MEMORANDUM

TO	Holly Archer, Cessnock City Council
CC	
FROM	Hulya Tugcu, NSW Public Works
DATE	17 September 2013
SUBJECT	Response to Draft Conditions
ATTACHMENTS	Appendix 1 & 2 (9 pages)

This memorandum responds to the conditions raised by Cessnock City Council in their proposed conditions issued on the 5th September 2013 for the proposed development at Kurri Kurri TAFE. The issues raised by Council and our comments have been summarised in the Table below.

Figure 1 – Cumulative Storage Curve

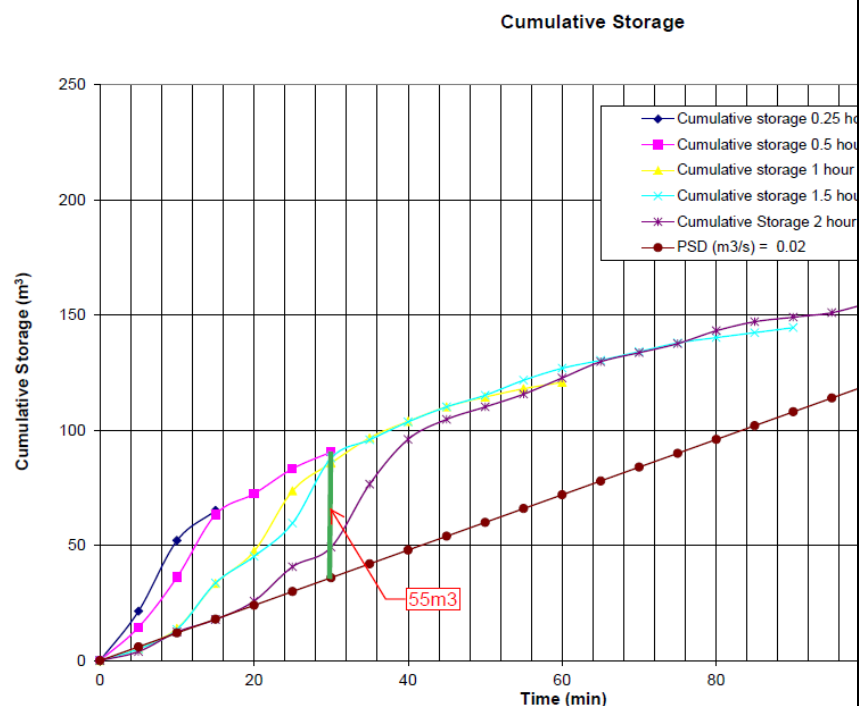
The applicant shall provide details of an on-site detention design for the newly proposed buildings. The on-site detention design will need to include plans and calculations in accordance with Council's 'Engineering Requirements', 'Australia Rainfall and Runoff 1987' and all relevant Australian Standards. This consent will not operate until the documentary evidence has been submitted to and approved by Council.	On-site Detention (OSD) involves temporary storage and controlled releases of stormwater generated from the proposed works, with benefits for downstream residents in small rainfall and large storm events. OSD system must be properly maintained to ensure that stormwater flows from the site are regulated for the life of the development.												
		Hydrological calculation for the OSD system has been carried out in accordance to AR&R1987, as a result of the increase in impervious areas for upto the 100 year ARI storm. Refer to Tables 1 and 2 and Appendix 1 details.

Therefore the required OSD storage for the proposed developments is 55 m³.

Additional surface runoff waters will be captured by the new rainwater tank system. Roof waters from Block O, P and Q will be collected via roof gutters, downpipes and into 3 x 20kL rainwater tanks.

3 x 20kL = 60kL

If 30% storage capacity of rainwater tank used for OSD = 60 kL x 0.3 = 18kL.

If 30% for OSD then you will need 55/0.3 = 183kL rainwater tank altogether.
